Product Change Notification

RE: 01560-79 Temperature sensor. OBSOLETE

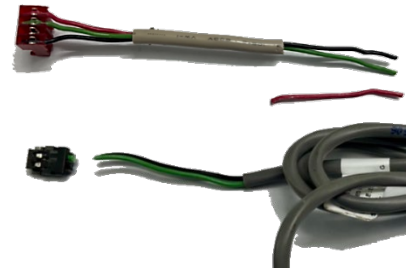
Affected models: All spas manufactured from 2000 to end of 2014.

Solution: Retrofit with Temperature sensor available; 01560-79YU.

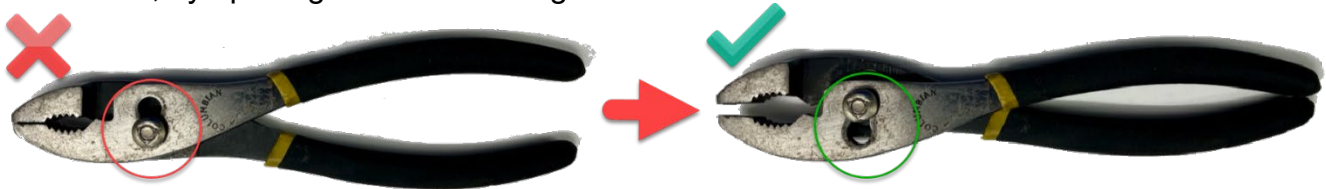
Original sensor: cut the wire 4" away from end connector.

Cut off about 1 ½" of insulation and discard the red wire.

New sensor: cut off the connector.

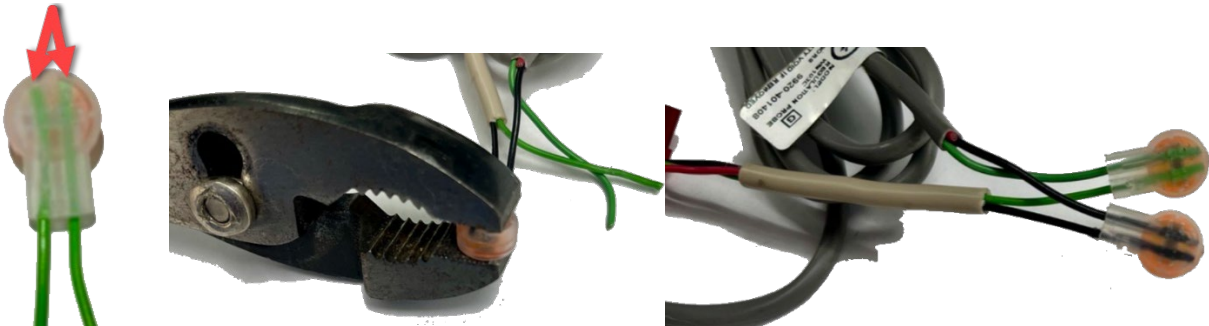
Note: If the special tool is not available, regular mechanical pliers can be used to crimp the connectors, by opening them to the "larger size".

Connect same color wires, verify they are fully inserted, hold them in place with one hand preventing the wires from coming out and crimp the connector with the other hand.
